Cambourne to Cambridge (CtoC) Scheme

CPPF Alternative Scheme – Engineering
Assessment

Project no. 70086660

Date: July 2025

Figure 3-3 - Standard Rural All Purpose Road Cross Section

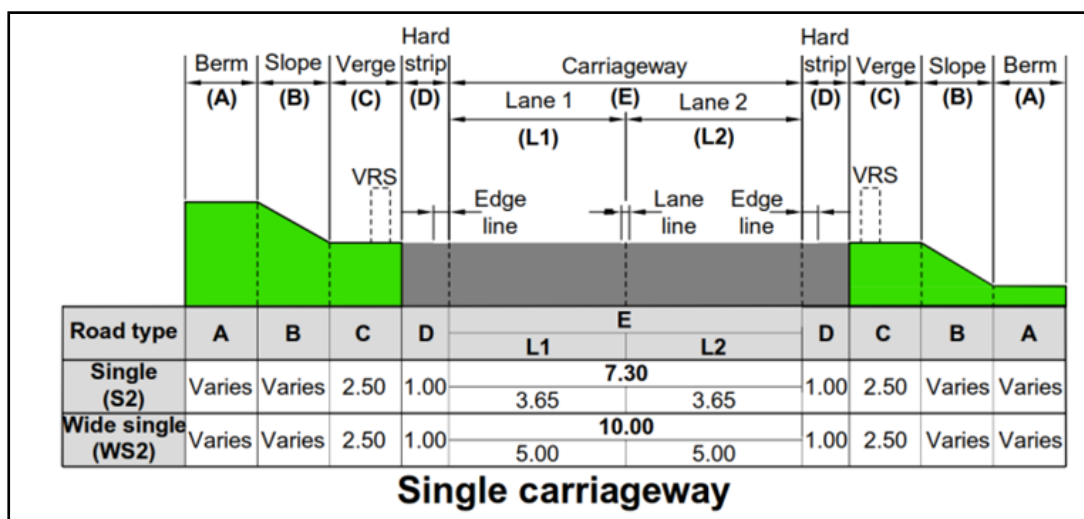
- 3.3.14. The standard cross section for a rural all-purpose single carriageway road consists of two 3.65m lanes, 1m hard strips, 2.5m wide verges and provision for cutting and embankment slopes which vary depending on the surrounding topography and boundary treatments.

- 3.3.15. Any deviation from the specified lane widths or the omission of hard strips would require a departure from standard. The 2.5m dimension given for verge widths is a minimum and this can be increased for several reasons the most common being to provide the requisite stopping site distances along the mainline and at side roads and accesses.

Figure 3-4 - Cross Section Proposed in CPPF Report

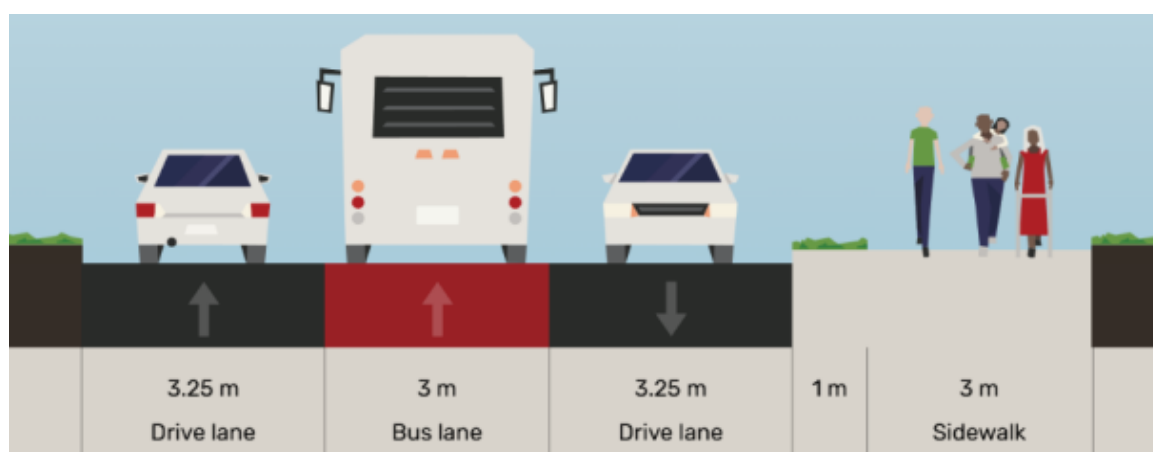
- 3.3.26. In summary the cross section and lane widths depicted in Figure 5 of the CPPF report (see **Figure 3-4** below) does not comply with the relevant design standards and does not include any provision for verges and other key features that would need to be accommodated within the overall cross-section. The total width of 13.5m stated in the CPPF report does not represent the true overall width of the corridor required to deliver an online bus lane.

Figure 3-5 - Compliant Cross Section based on CPPF Proposals

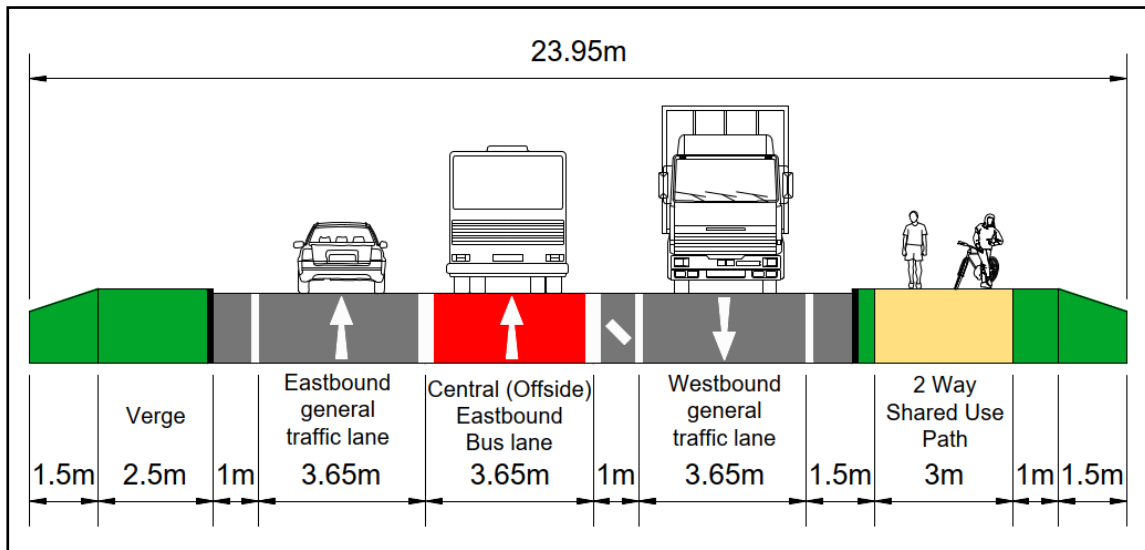
- 3.3.27. For comparison **Figure 3-5** below provides an indication of how a compliant cross section based on the CPPF proposals might look and the likely overall corridor width required to accommodate it. A 1.5m allowance has been included in the cross section for earthworks. This is based on an assumed 0.5m level difference at the back of the verge and a 1in3 embankment/cutting slope. The total width of the cross section comes to approximately 24m and may exceed this in areas where verge widening is required to provide the requisite stopping sight distances and visibility splays at junctions or where more significant level differences exist.

Figure 3-6 – Impacts on Existing Features to the South of Madingley Road

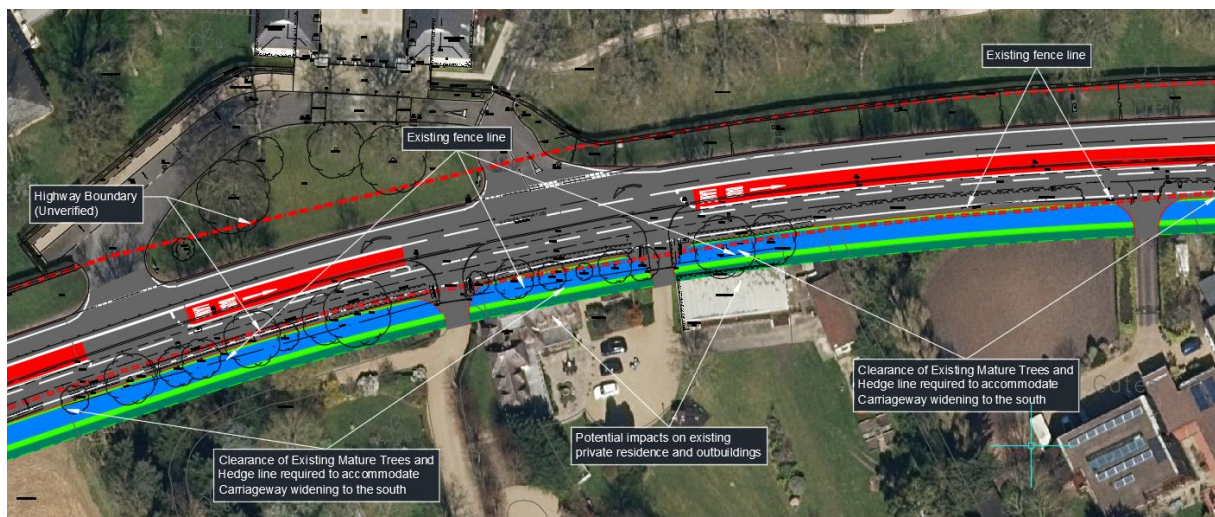
- 3.3.28. The existing kerb line on the north side of Madingley Road has been retained when developing the concept design for the central (offside) bus lane and the active travel provision remains on the south side of the carriageway. Widening to the south is considered by both Natural England and Historic England to pose less risk of direct impacts on the woods and cemetery sites as described in their responses to consultations in 2017 **[Appendix D]**.
- 3.3.29. The additional width required to deliver the proposed cross section will necessitate acquisition of land outside of the highway boundary and will impact the existing features along Madingley Road including the commercial and residential properties to the south. **Figure 3-6** below provides an indication of the level of impact that the CPPF scheme may have.

Figure 3-7 - Existing Mature Trees and Hedge Line

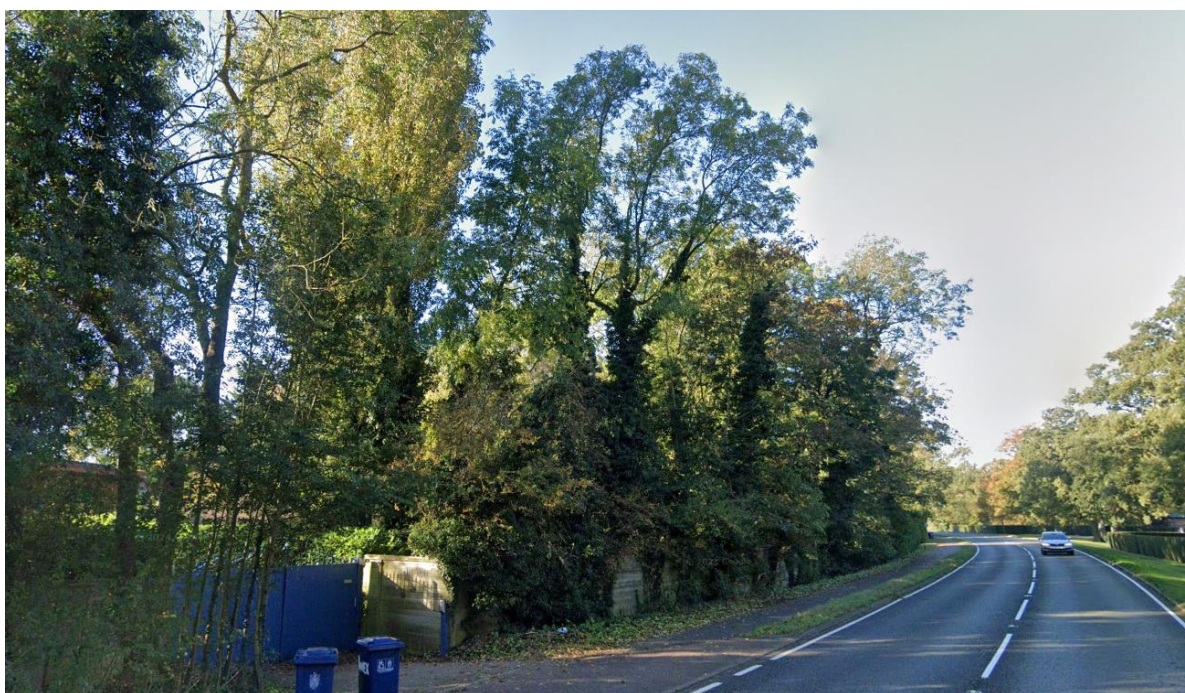
- 3.3.30. Extensive clearance of the existing trees (including mature specimens) and hedge lines to the south of Madingley Road depicted in **Figure 3-7** below, would also be required to facilitate the construction of the proposed CPPF scheme.

Figure 3-10 – Compliant Typical Cross Section with Nearside Bus Lane

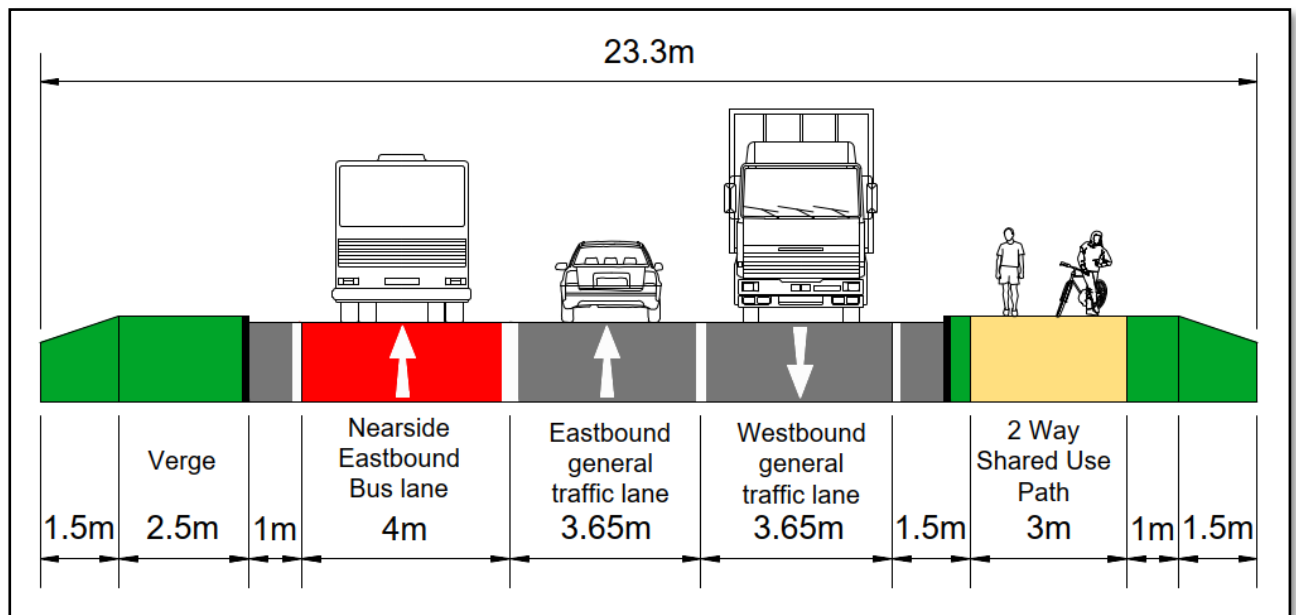
- 3.5.8. **Figure 3-10** below shows a typical cross section through the alternative scheme layout and provides an indication of the overall corridor width required to accommodate it. A 1.5m allowance has been included in the cross section for earthworks. This is based on an assumed 0.5m level difference at the back of the verge and a 1in3 embankment/cutting slope. The total width of the cross section comes to approximately 23.3m and may exceed this in areas where verge widening is required to provide the requisite stopping sight distances and visibility splays at junctions or where more significant level differences exist at the interfaces with the existing ground.
